**Technical Service Bulletin (TSB)**  
**Radio Over The Air Update from**  
**QR39.82F to QR40.12 Software Version**

| <b>REFERENCE:</b>         | <b>TSB:</b> 08-028-24<br><b>GROUP:</b> 08 - Electrical  | <b>Date:</b> | January 30, 2024 | <b>REVISION:</b>                       | -                            |

**Fig. 1**  
Software Acceptance Screen

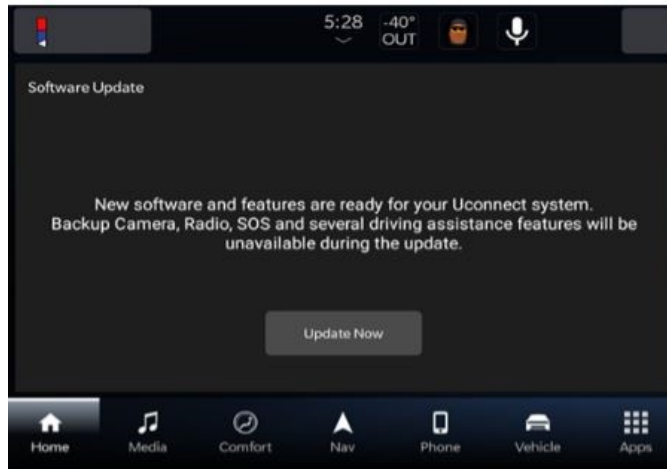
1. The vehicle needs to be in ‘Park’. The ignition needs to be in the off position.
2. If the customer selects “Update Now” they can shut off the vehicle and leave. The update will be completed automatically [Fig. 1](#).

**Fig. 2**  
Software Update Confirmation Screen

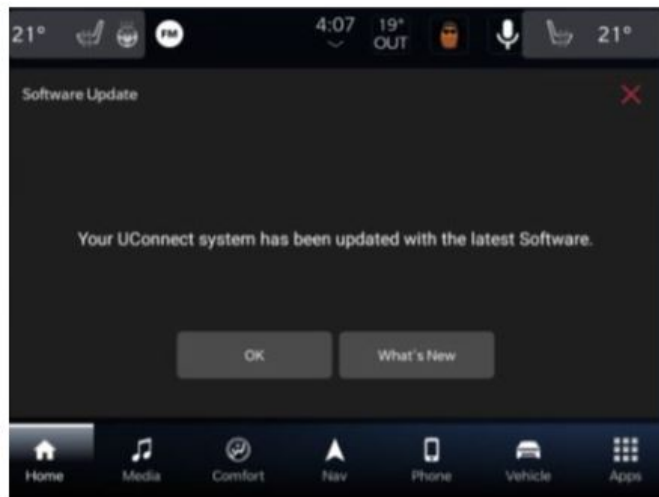
3. Upon completion of update, the radio will display a confirmation message [Fig. 2](#).
